The Commission has issued the enclosed Amendment Nos. 69, 65 and 41 to Facility License Nos. DPR-33, DPR-52 and DPR-68, respectively, for the Browns Ferry Nuclear Plant, Units Nos. 1, 2 and 3. These amendments consist of changes to the Appendix B Environmental Technical Specifications in response to your request dated August 29, 1979 (TVA BFNP TS 130).

BROWNS FERRY NUCLEAR PLANT, UNIT NO. 1

AMENDMENT TO FACILITY OPERATING LICENSE

Amendment No. 69
License No. DPR-33

Figure 4.2-1

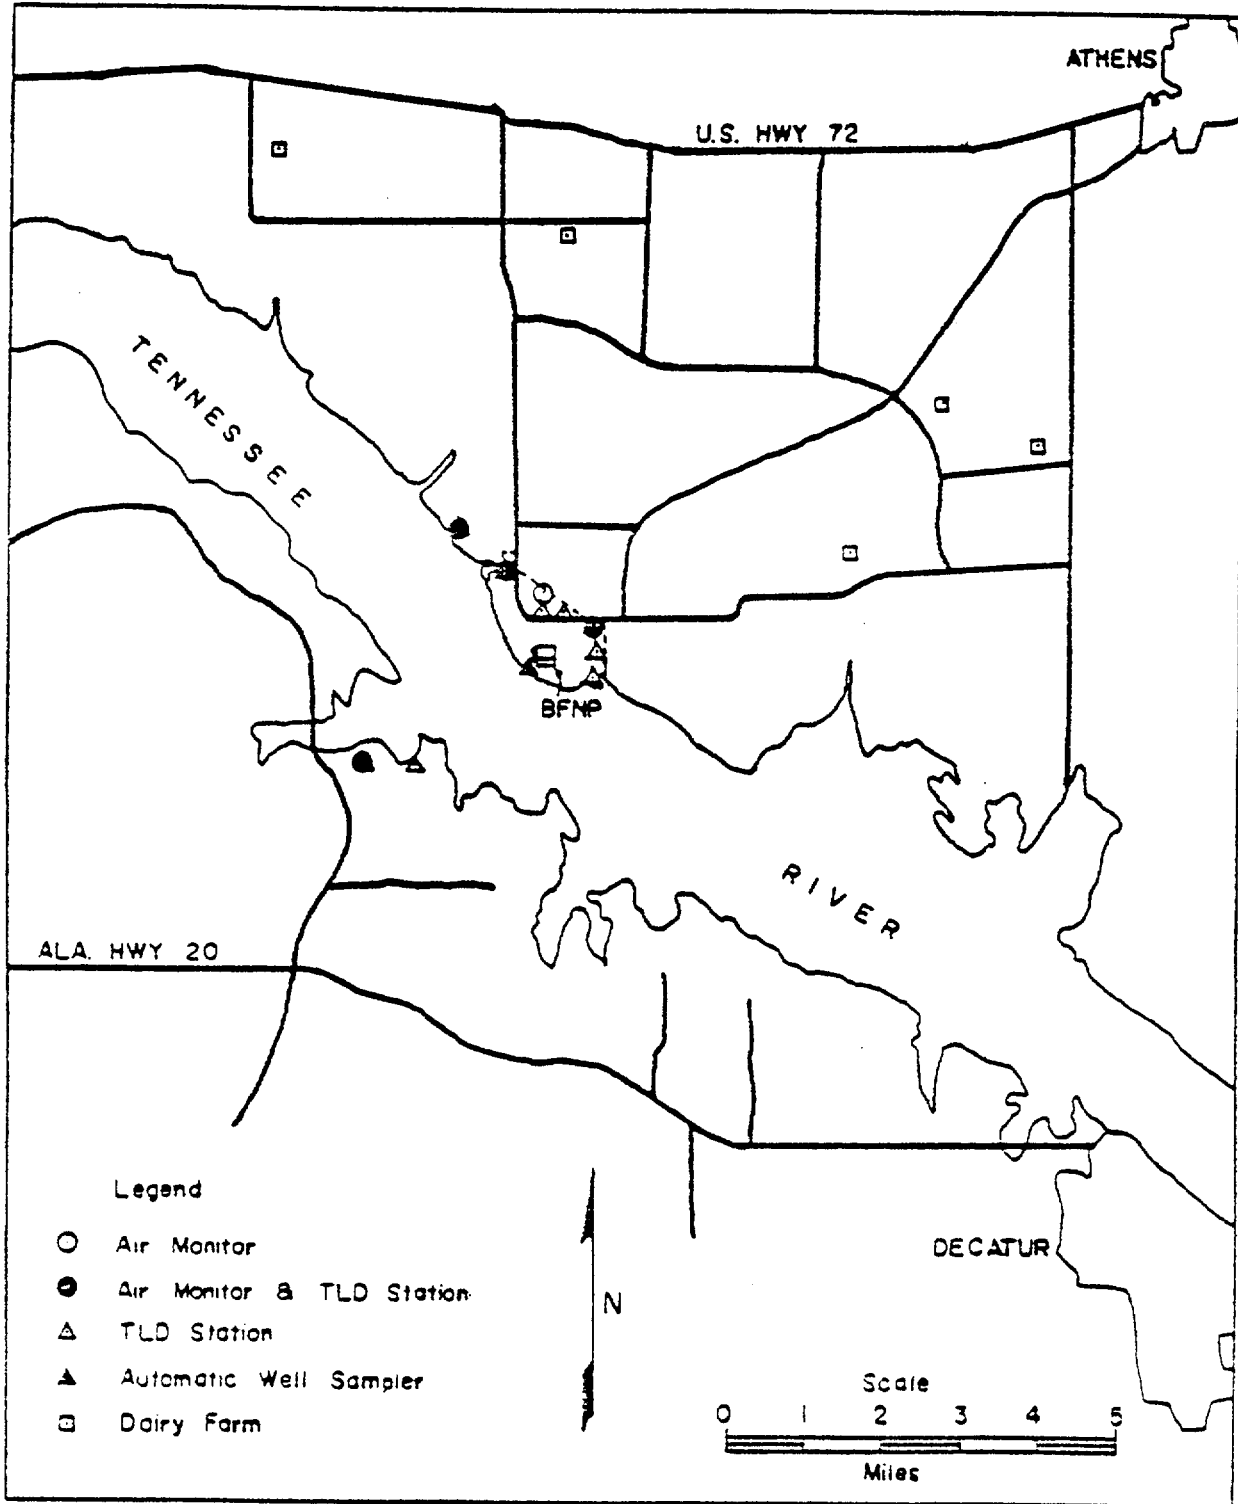
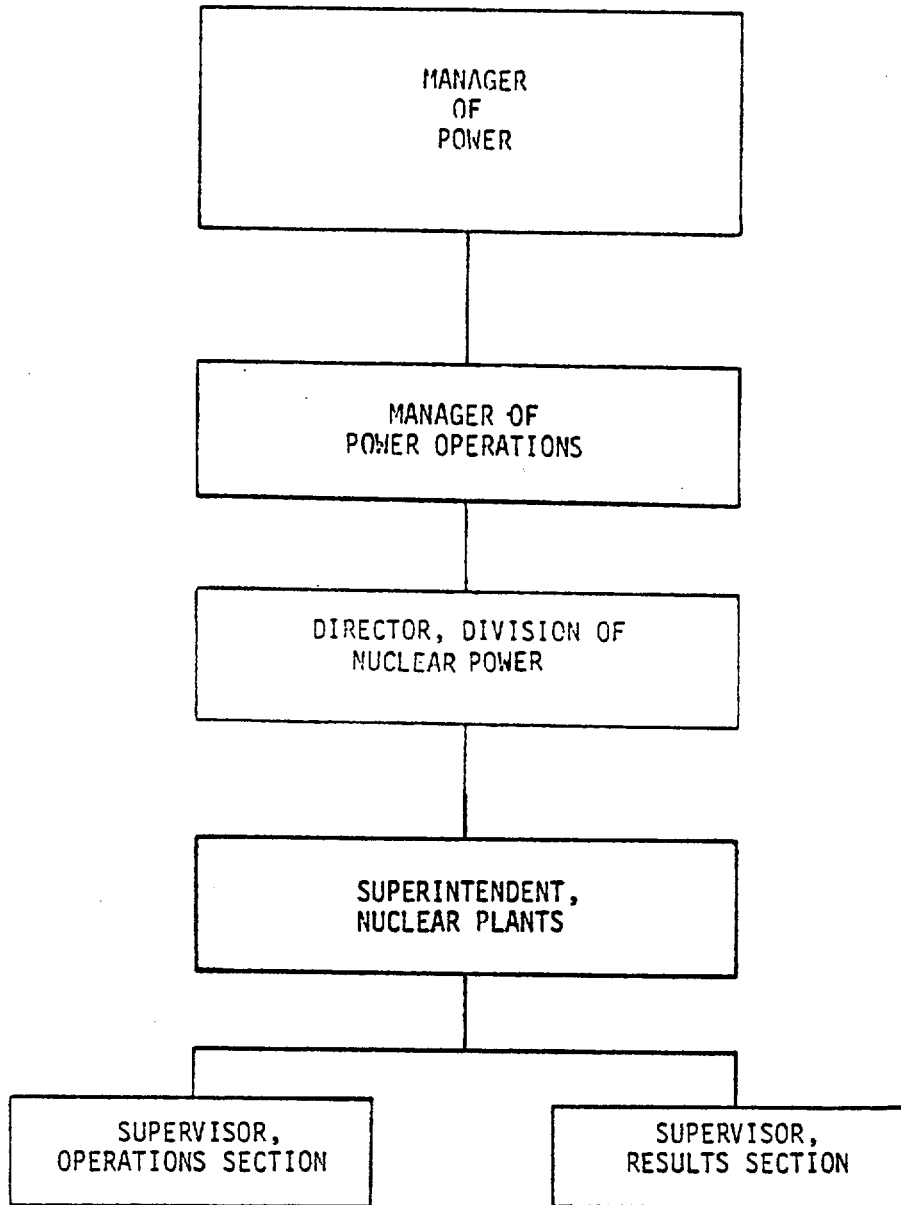
These amendments revise the Environmental Technical Specifications to:
(1) delete section 2.1 which presently specifies limiting conditions of operation (LCO) on thermal discharge limits, (2) delete section 2.2 which specifies LCOs for chemical discharges to the aquatic environment, (3) delete section 3.1.2 which describes the expected maximum concentrations of chemicals of the plant effluents before and after mixing in the river, (4) delete Section 5.4 which specifies actions to be taken if a water quality LCO is exceeded, (5) delete section 5.6.3.b which specifies reporting requirements when an LCO on water quality is exceeded, (6) delete item 5.7.1.C which specifies the records and logs to be maintained on LCO violations of water quality and (7) change the titles in section 5.0 (Administrative Controls) of the offices within TVA responsible for environmental activities.

BROWNS FERRY NUCLEAR PLANT
TVA Office of Power
Organization for Operation
of Nuclear Plants
Figure 5.2-1

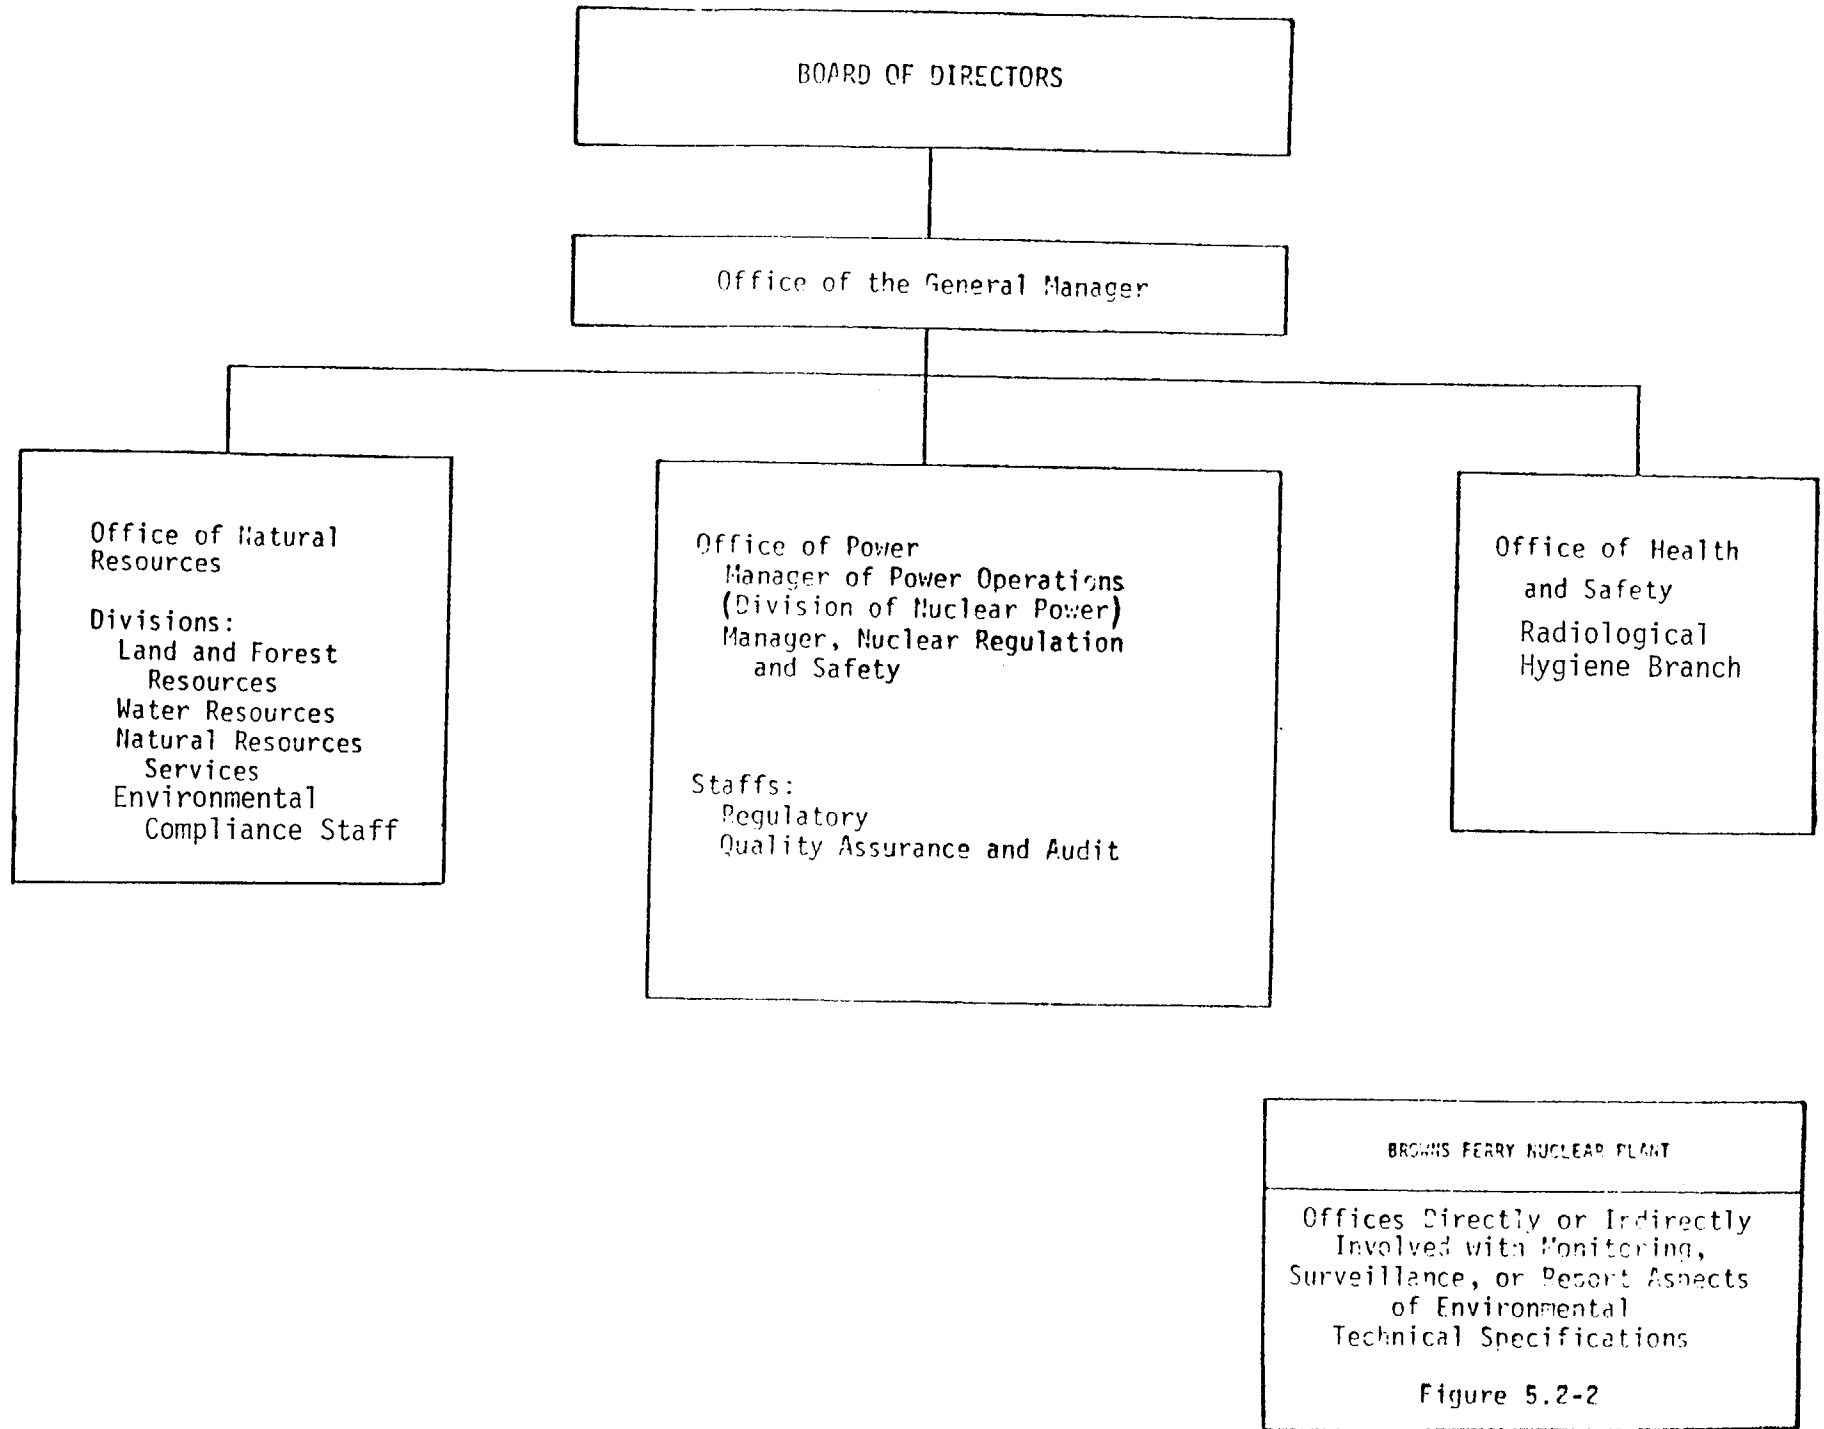
These amendments revise the Environmental Technical Specifications to (1) delete water quality and aquatic monitoring and reporting requirements which duplicate those conditions regulated by the Browns Ferry Nuclear Plant's NPDES Permit No. AL0022080 issued to TVA on June 30, 1977 and (2) change the titles in Section 5.0 (Administrative Controls) for the offices within TVA responsible for environmental activities to reflect recent organizational changes.
